City of Carlisle, Iowa
Planning and Zoning Commission
Regular Meeting
July 18, 2022

RE: Ridgewood Valley Plat 1 – Construction Drawing Review
PROJECT #7023.057

RE: Ridgewood Valley Plat 1 – Final Plat Review
PROJECT #7023.058

MARK	REVISION	DATE	BY
	Checked By: CDD	Scale: 1" =	
	Engineer: MLS	Date: 07-01-2022	
	Technician: MLS	T-R-S: 77N-23W-16	
Project No: 121.0728.01			Sheet C400

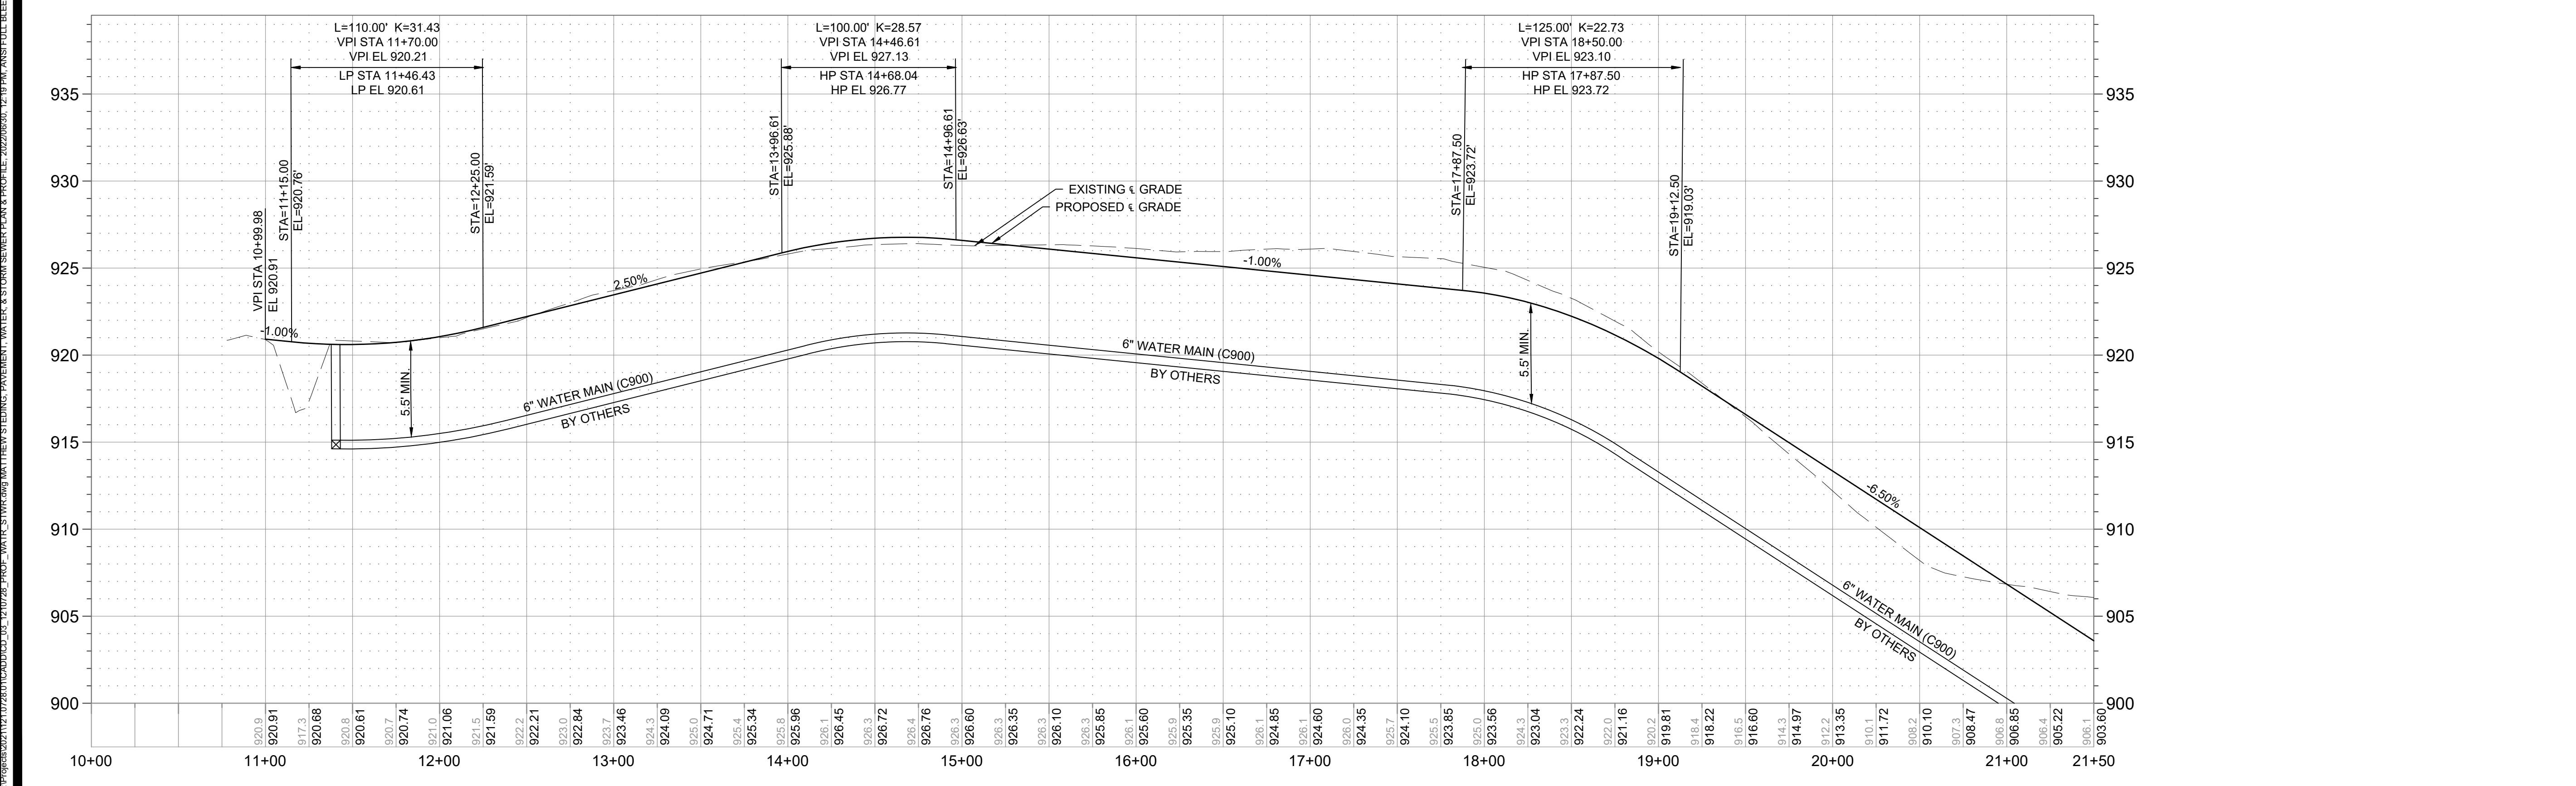
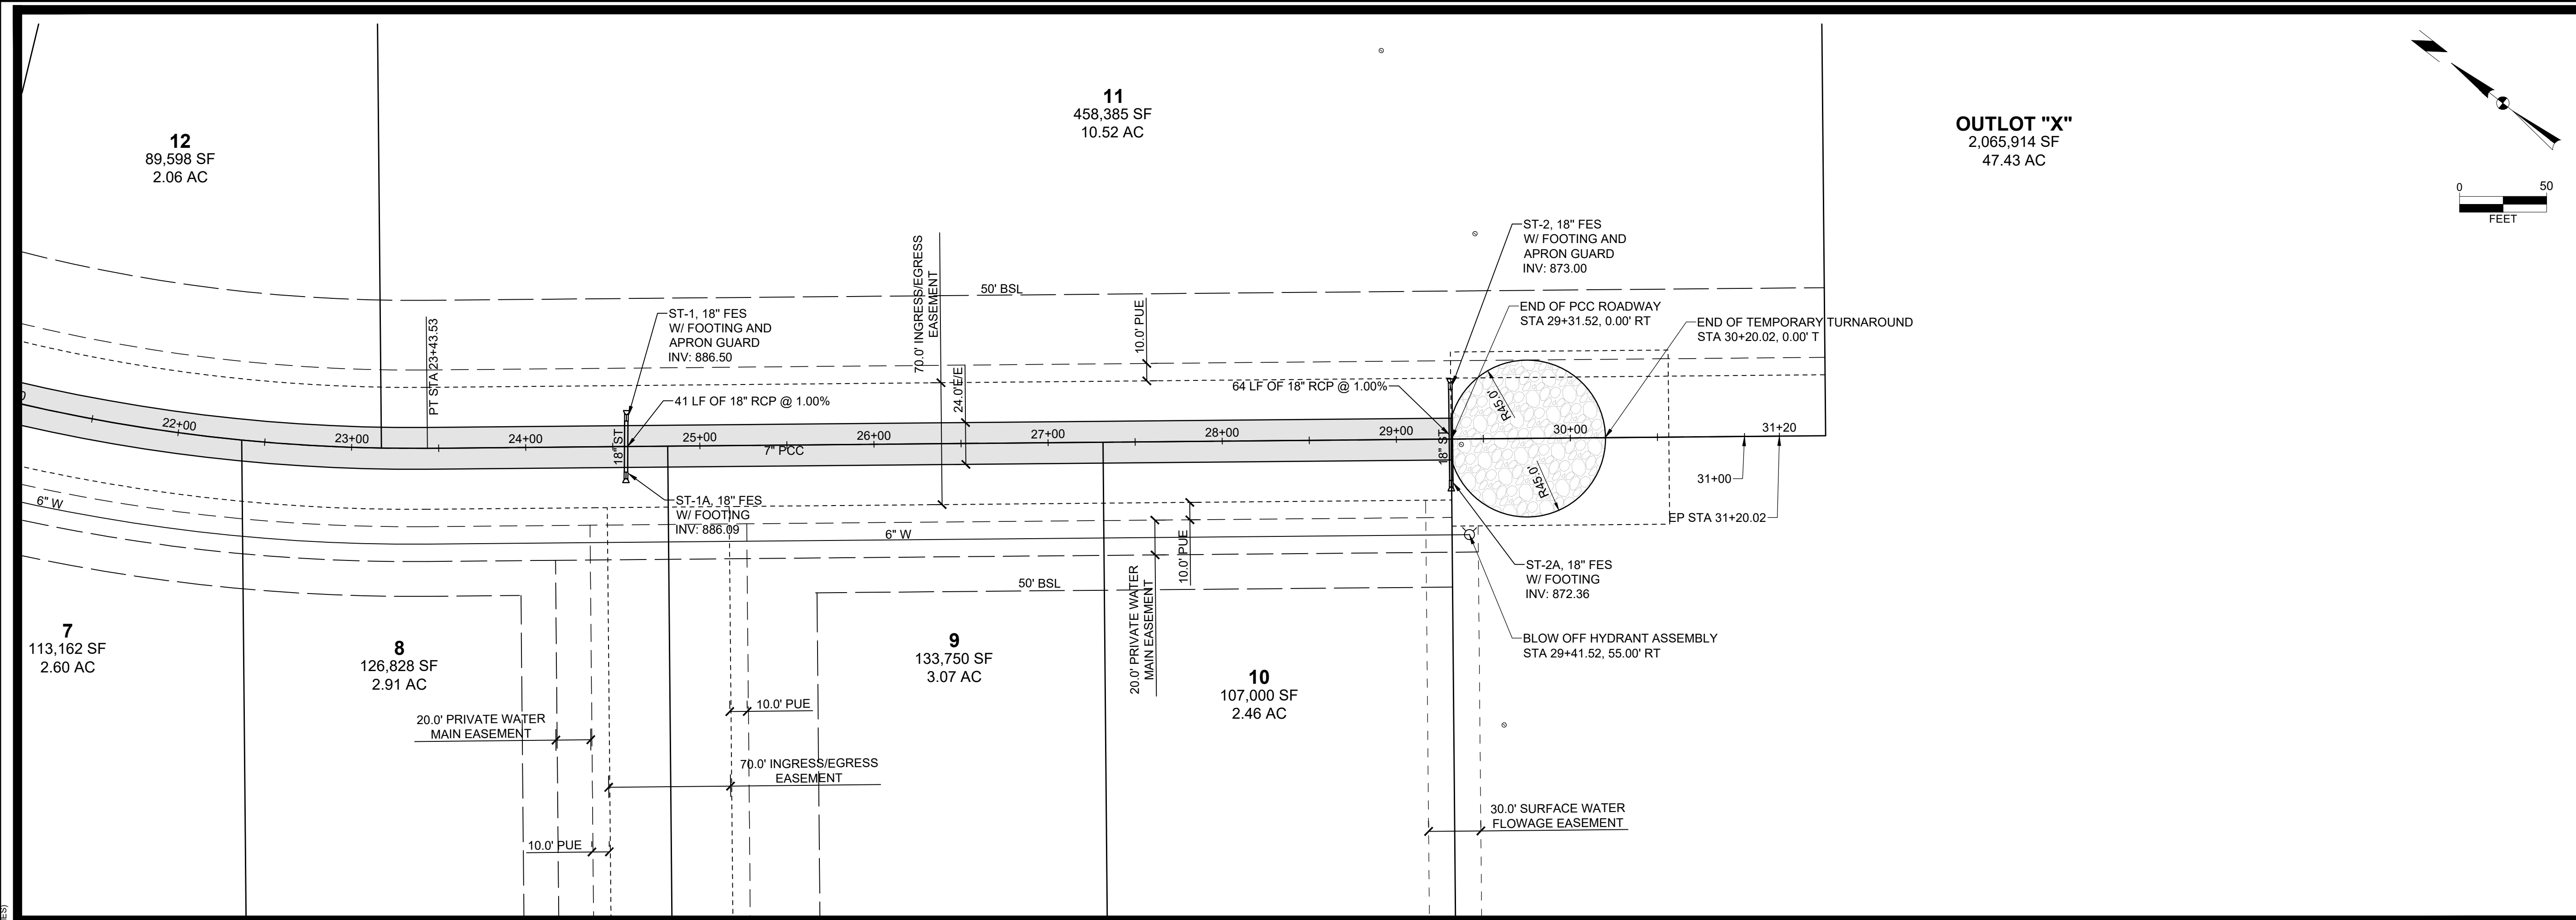
10. Please revise the connection note to be an existing 6-inch water main.
11. Please consider providing entrance tapers per the attached example from Danamere Farms (also on Scotch Ridge Road, within Carlisle City Limits).
12. Please label the roadway centerline alignment radii.
13. Will water services be extended to the east side of the roadway? Please show where curb stops will be installed. If none are planned at this time, please provide a typical detail that shows the curb stops at the edge of the Ingress/Egress Easement (or where it makes sense based on grading) to have consistent placement throughout the subdivision.
14. It is understood that hydrants are being eliminated to save cost and to prevent collapse of the Rural Warren water main. However, it is going to be advisable to provide a blowoff of some sort near STA 14+50 as it is a high point and will collect air.

Project No: 121.0728.01
Sheet C401

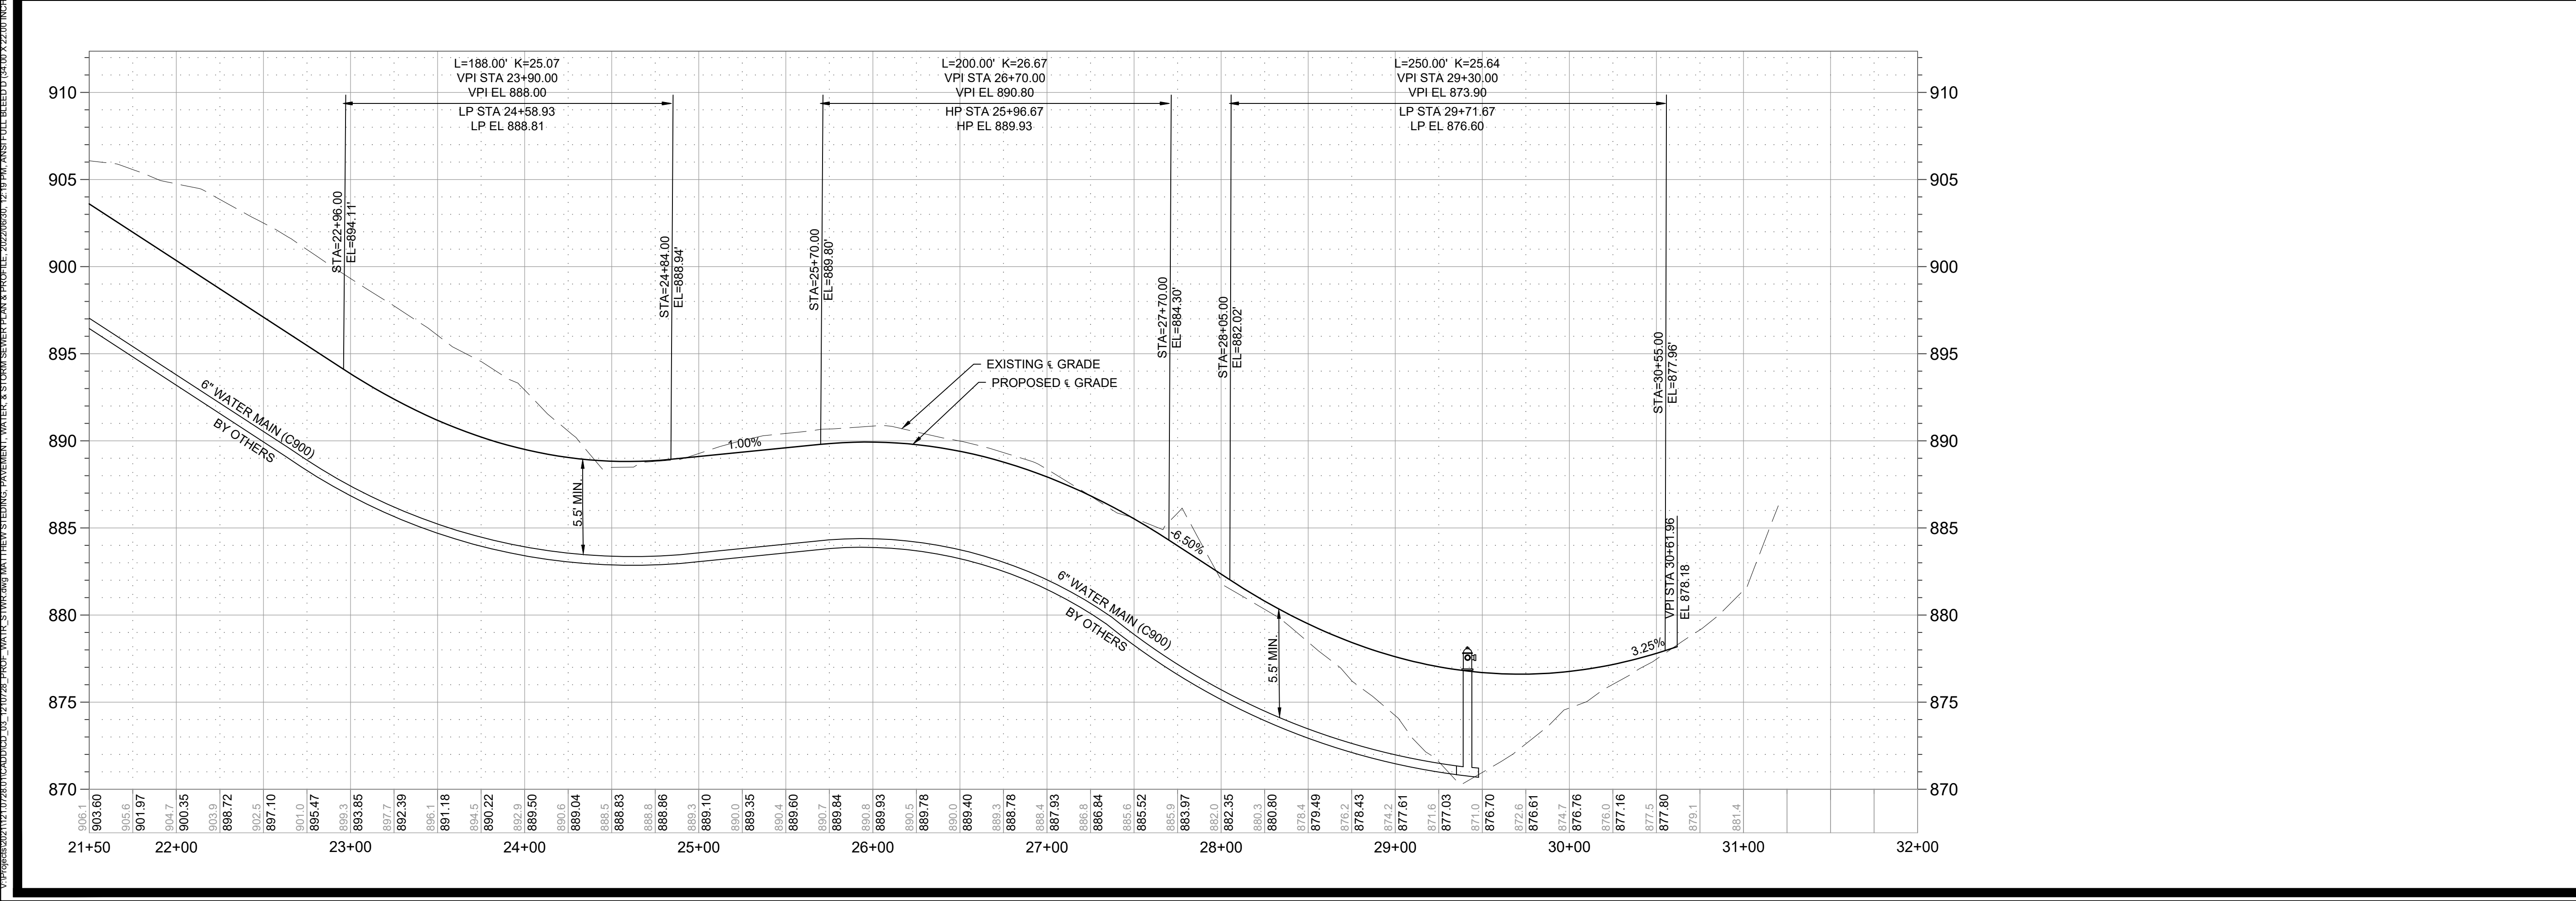
15. Please review the grading from STA 21+00 to STA 24+50 as there looks to be approximately 5.5' of cut in this area. Will subdrains be necessary to mitigate the effect of groundwater in this area? FOX Strand recommends subdrain in this area to help divert groundwater in cut areas.
16. Please provide an in-line 6-inch valve at the mid-point of the water main and no less than 20-ft from the fire hydrant. Maximum valve spacing per SUDAS is 800-ft in residential areas. Also, a valve will be needed for future connections/extensions to the south.
17. Please review the vertical profile over the 18-inch pipe at STA 24+50. It appears that the roadway will rest directly on the 18-inch pipe (may be in direct conflict). Please provide a minimum of 1-ft of fill over the pipe and under the pavement per SUDAS.
18. Please modify the water main profile near STA 26+00 to eliminate the high point.
